# TRAFFIC QUEUING ANALYSES

**Subject: 556 El Camino Real - Parking**

# 556 EL CAMINO REAL

***Re: Peer Review of the Queuing Analysis Completed for the Proposed Residential Project at 556 El Camino Real in Burlingame, California***

BASEMENT (GARAGE) PLAN  
SCALE 3/16"=1'-0"

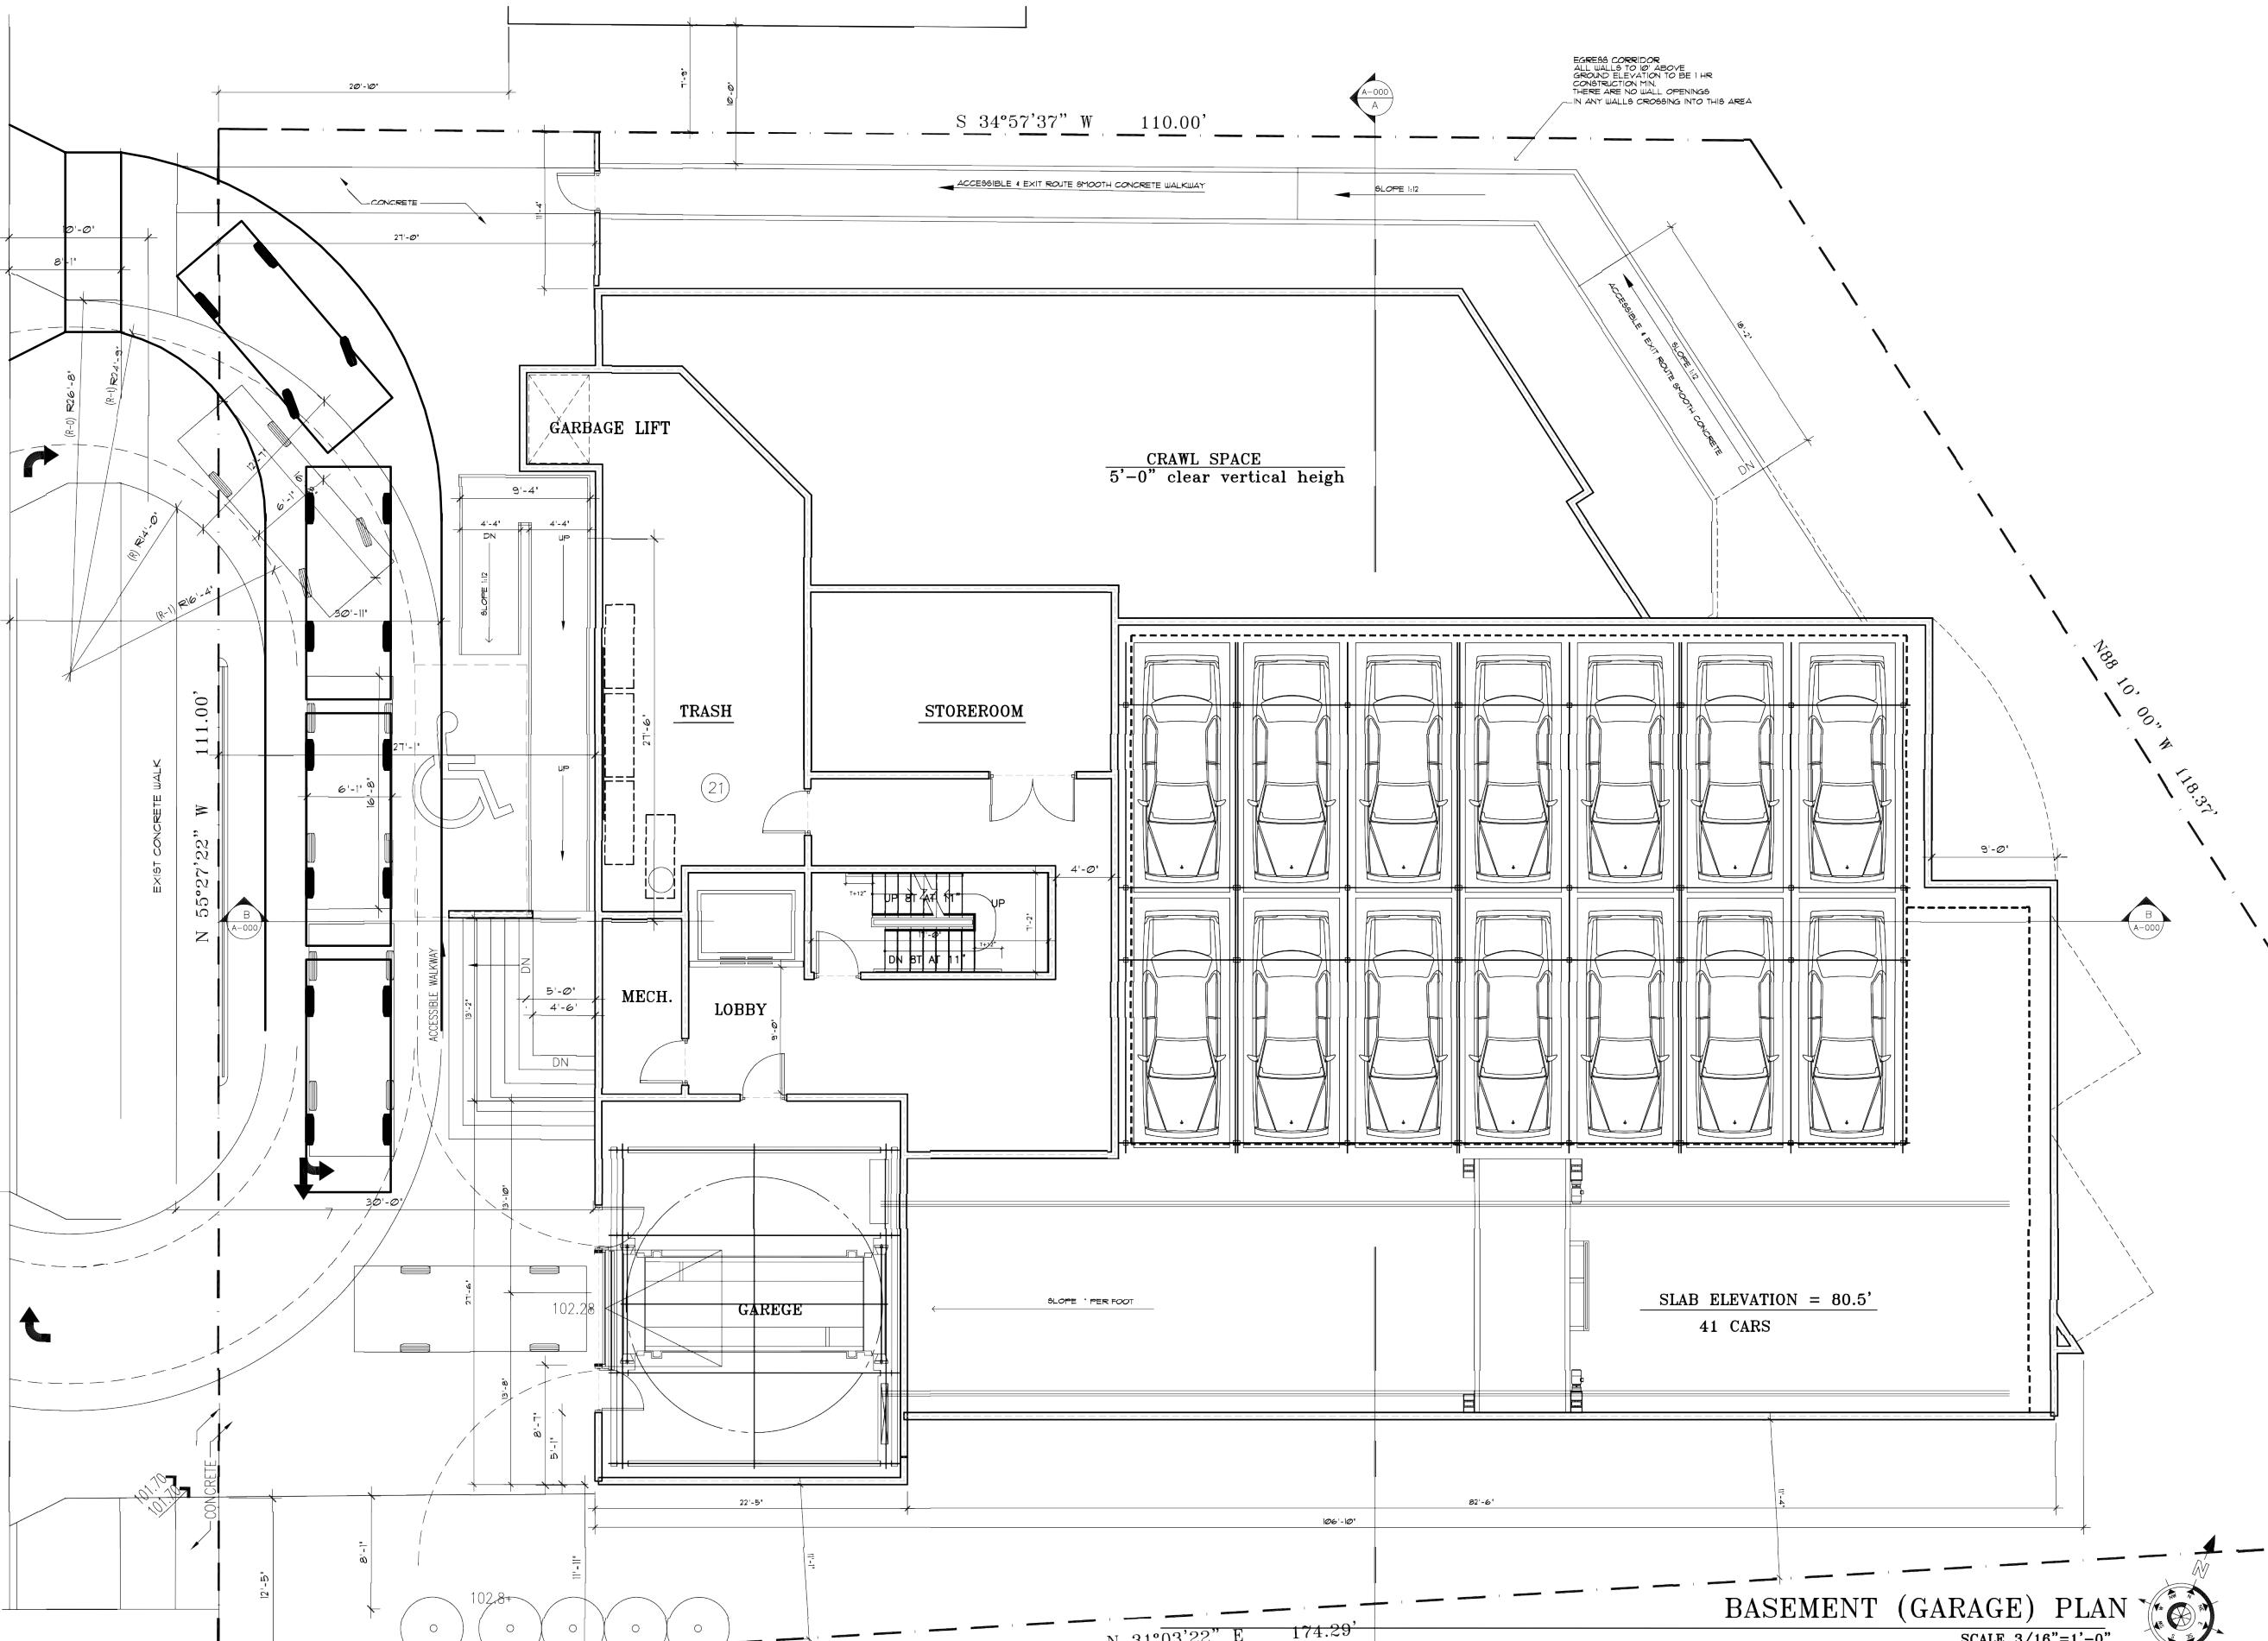
I have reviewed the information provided regarding a parking queue for residents while utilizing the automated parking structure. Based on the information provided, it appears that a traffic engineer has estimated that the peak 15-minute traffic rate generated from the new development would create a 3 car backup while operating the automated stacker. The current design provides ample room for three cars in the driveway, however the City is requesting additional space. It is unclear how many additional spaces the City is requesting.

It appears that room for a fourth car is almost available in the current design. Pulling building back from El Camino would only add one car, there is not enough space to add any more and maintain a single line. Extending the driveway closer to the property line would be more effective since there is more space to increase driveway length. Regardless, alternative means may be preferable to avoid backup on El Camino Real. My recommendations are summarized below:

- Lengthen driveway towards the property's westerly boundary. This shift would be more effective than pulling back from El Camino since there is more space in that dimension.
- A fourth car would create a factor of safety of 33%, which seems adequate for this project.
- Notify future residents that blocking ECR is not allowed. If the queue is full, residents must circle the block.
- Provide signage to this effect as requested by traffic engineer.
- Paint stripes in driveway to place cars in order. This could prevent excessive separation between cars and show incoming residents whether all spaces in the queue are full.
